Project	IEEE 802.16 Broadband Wireless Access Working Group < http://ieee802.org/16 >	
Title	Pilot Arrangement in FUSC – Reply to Comment #433	
Date Submitted	2004-07-08	
Source(s)	Ran Yaniv Tal Kaitz Naftali Chayat Vladimir Yanover Marianna Goldhammer	Voice: +972-37674583 mailto: ran.yaniv@alvarion.com Voice: +972-36456273 mailto: tal.kaitz@alvarion.com
	All with Alvarion Ltd. 21 A Habarzel St. Ramat - Hahayal Tel - Aviv 69710	
Re:		
Abstract	Proposal for modifications to the pilot allocation of the FUSC scheme in OFDMA mode.	
Purpose	Reply to comment #433	
Notice	This document has been prepared to assist IEEE 802.16. It is offered as a basis for discussion and is not binding on the contributing individual(s) or organization(s). The material in this document is subject to change in form and content after further study. The contributor(s) reserve(s) the right to add, amend or withdraw material contained herein.

Pilot Arrangement in FUSC: Reply to Comment #433

Figure 2 - Downlink FUSC, 2-antenna STC

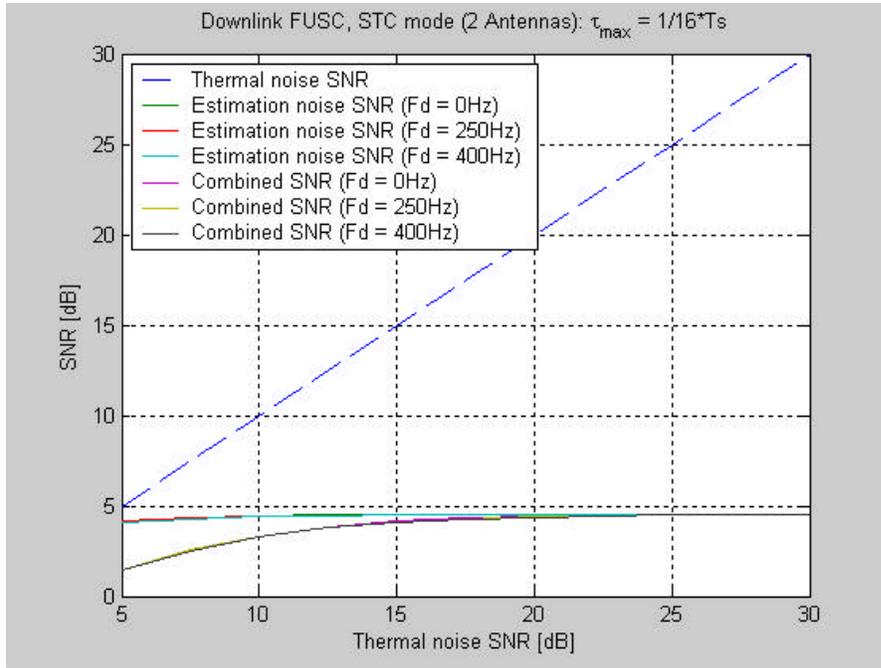
In the 2-antenna STC mode, half of the pilots are available to each transmitting antenna, hence the pilot spacing is in effect doubled to 12 subcarriers over the 2 symbol cycle. Pilots are boosted by 2.5dB⁽¹⁾. This limits the maximal supported single-sided delay

spread to $\frac{1}{24} \cdot T_{sym}$ without any over-sampling. Figure 2 shows the estimation S/N and combined S/N⁽²⁾ for $t_{max} = \frac{1}{16} \cdot T_{sym}$.

Clearly at this multi-path level pilot-aided channel estimation is useless.

Figure 3 - Downlink FUSC, 4-antenna STC

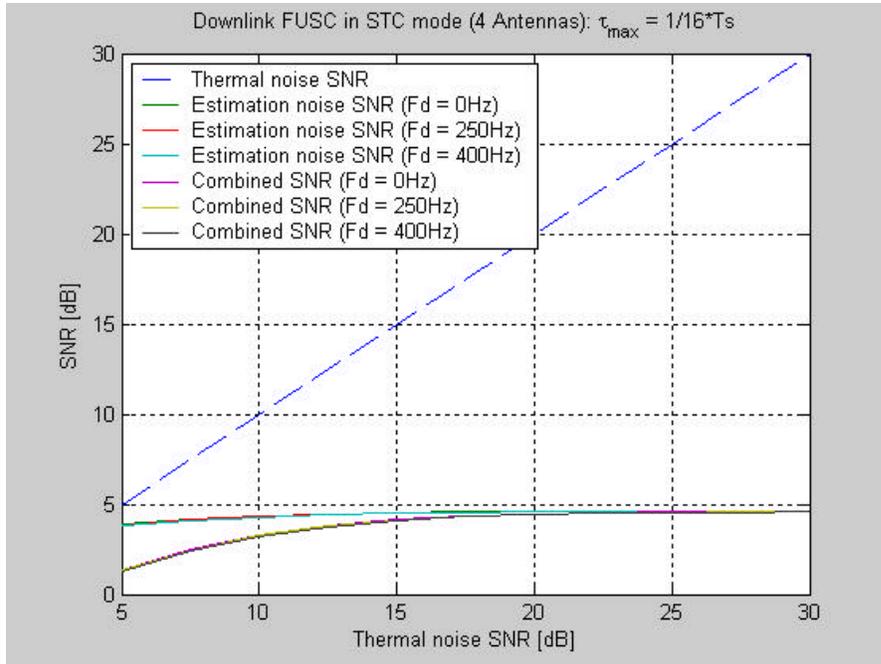
In 4-antenna STC mode, every two symbols two antennas share the available pilots.

Figure 3 shows how this scheme fails for $t_{max} = \frac{1}{16} \cdot T_{sym}$.

Figure 4 – Downlink FUSC

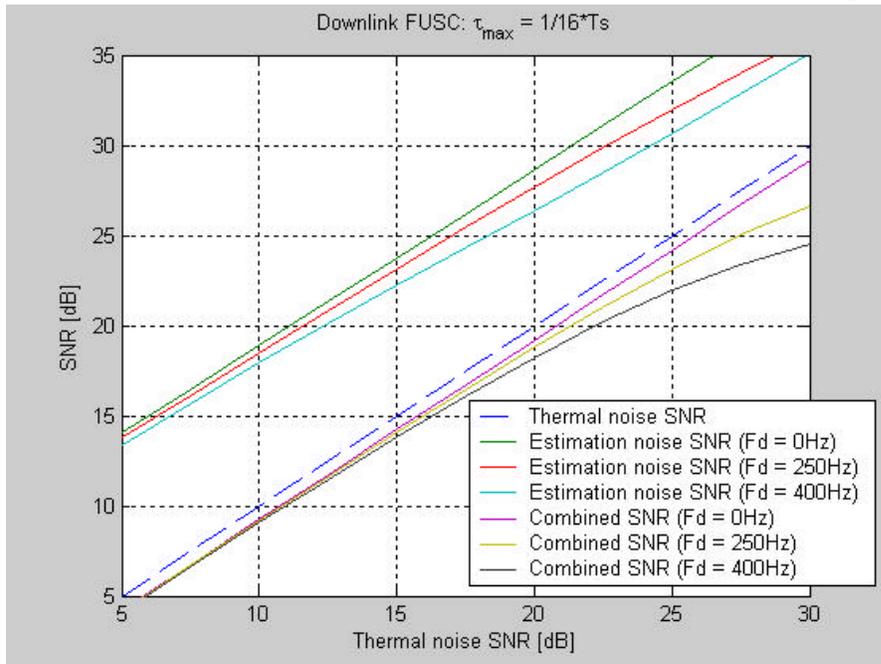
The pilot spacing for the non-STC FUSC scheme is 6 subcarriers over a cycle of 2 symbols. For $f_d=0$, the maximal single-sided delay that can be supported is $\frac{1}{12} \cdot T_{sym}$ without over-sampling. Figure 4 shows the estimation S/N and combined S/N⁽³⁾ for $t_{max} = \frac{1}{16} \cdot T_{sym}$.

Figure 5 - FUSC structure

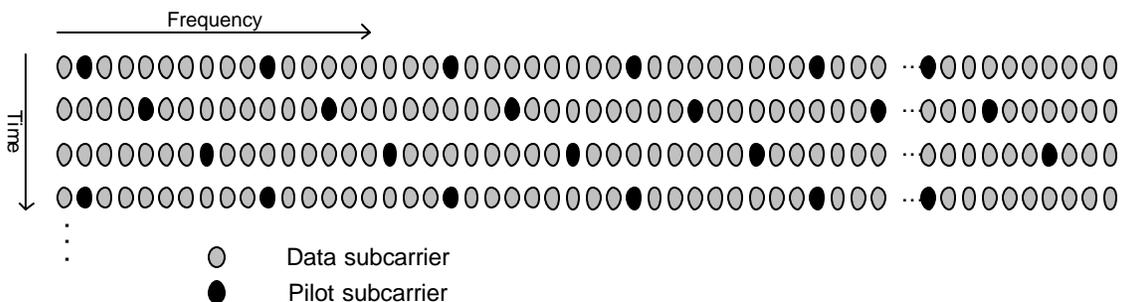
4. For the non-STC case:

Select the pilots at each symbol to be the union of PilotSet#0 and PilotSet#1.

This is depicted in Figure 5.

Figure 6 - FUSC structure with STC

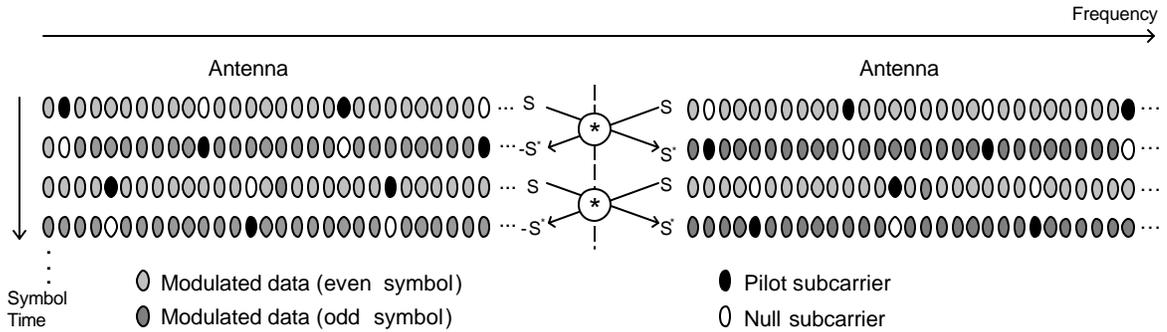
5. For the 2-Antenna STC case:

Select the pilots at each symbol as follows:

- For even symbols, select PilotSet#0 for antenna #0 and PilotSet#1 for antenna #1.
- For odd symbols, select PilotSet#1 for antenna #0 and PilotSet#0 for antenna #1.

This is depicted in Figure 6.

Figure 7 – Comparison between current and proposed FUSC pilot structure, 2-Antenna STC.

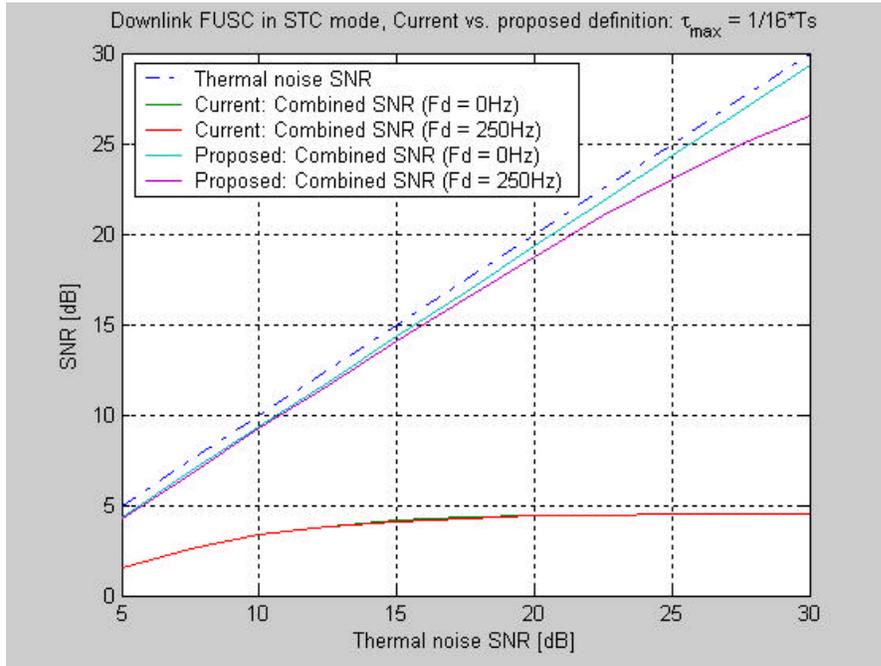
The figures below compare the channel estimation performance of the current FUSC structure definitions vs. the definitions proposed in the previous subsection. Results show n are the combined SNR for Doppler spreads of 0Hz and 250Hz with $t_{max} = \frac{1}{16} \cdot T_{sym}$.

For the STC modes, the proposed modification leads to a very significant improvement. Results are shown in Figure 7 and Figure 8 below.

Figure 235 – Downlink symbol structure for symbol number 0 using FUSC

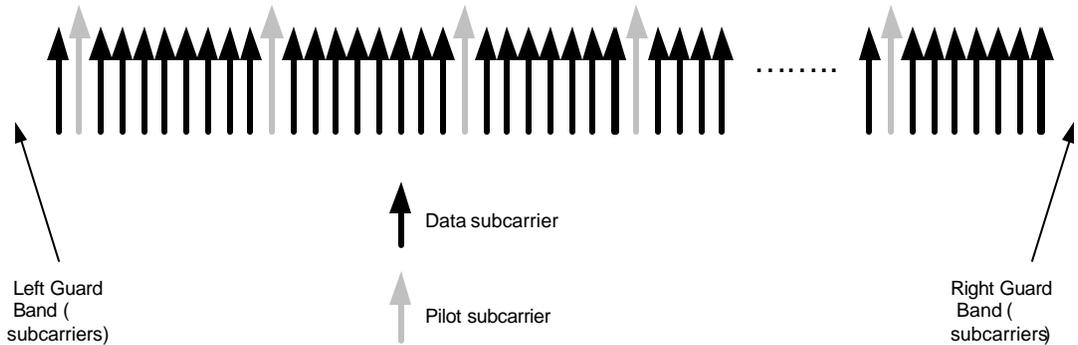
Figure 235 depicts as an example of the symbol allocation ~~for segment 0~~ on symbol number ~~1~~ 0:

[Replace figure 235 with the following figure:]

Figure 247 – STC usage with FUSC

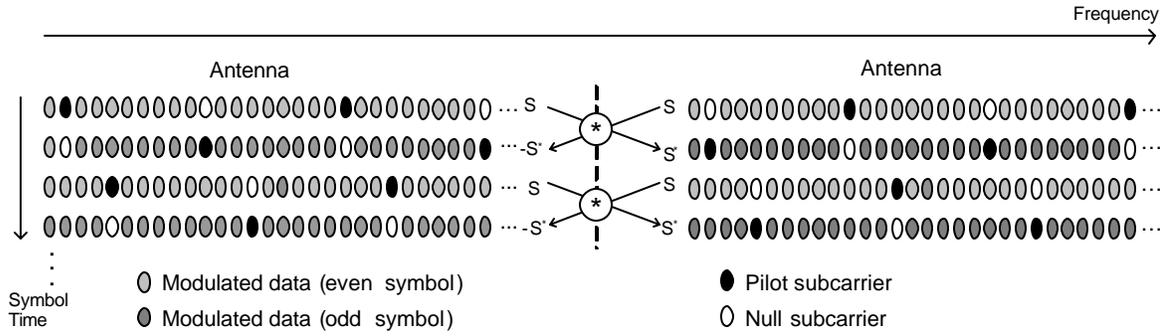
[Replace text starting with “In FUSC all subchannels” and ending with “as illustrated in Figure 247” with the following text:]

In FUSC all subchannels shall be used for STC transmission and the pilots within the symbols shall be divided between the antennas. Pilot sets are defined by equation (X1) with $K_{STC}=2$. For even symbols, transmitted pilots are PilotSet#0 for antenna #0 and PilotSet#1 for antenna #1, while for odd symbols, transmitted pilots are PilotSet#1 for antenna #0 and PilotSet#0 for antenna #1. The transmission of the data shall be performed in pairs of symbols as illustrated in Figure 247.

[Replace figure 247 with the following figure]
